## APPENDIX I – RESPONSE TO REQUESTS 62 AND 66

# Response to IHP Hearing Requests

- Week 7 Topics- Specific Purpose: Clare Piper

### Notified:

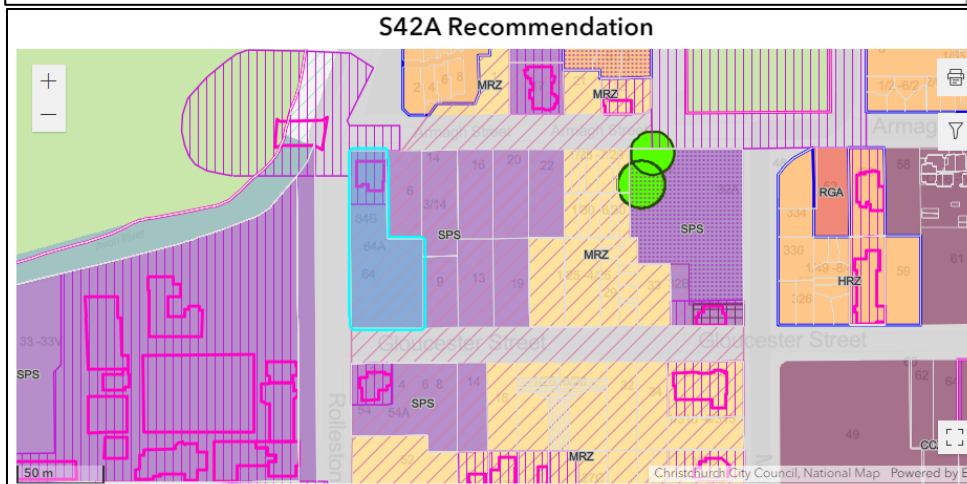
**Question #62: Confirm whether Christ College's submission seeking to rezone the alternative zone underlying their specific purpose school zone to HRZ is within scope given the site was inadvertently notified as HRZ and later re-notified as MRZ**

The notified proposed alternative zone for the Christs College site was HRZ, whilst the notified planning maps for this area show the surrounding residential zone as proposed to be MRZ (QM RCA applied).

For the above reasons, in considering the merit of the submission #699, it was determined that the notified alternative zone of HRZ for Christs College should not be applied, unless the surrounding residential land is also to be HRZ, which would only occur if the RHA QM was to be removed. This submission was therefore not supported and was recommended to be rejected.

Having considered this matter further, for the above reasons my recommendation in para 8.3.9 of my s42A Report, to reject the submission remains unchanged.
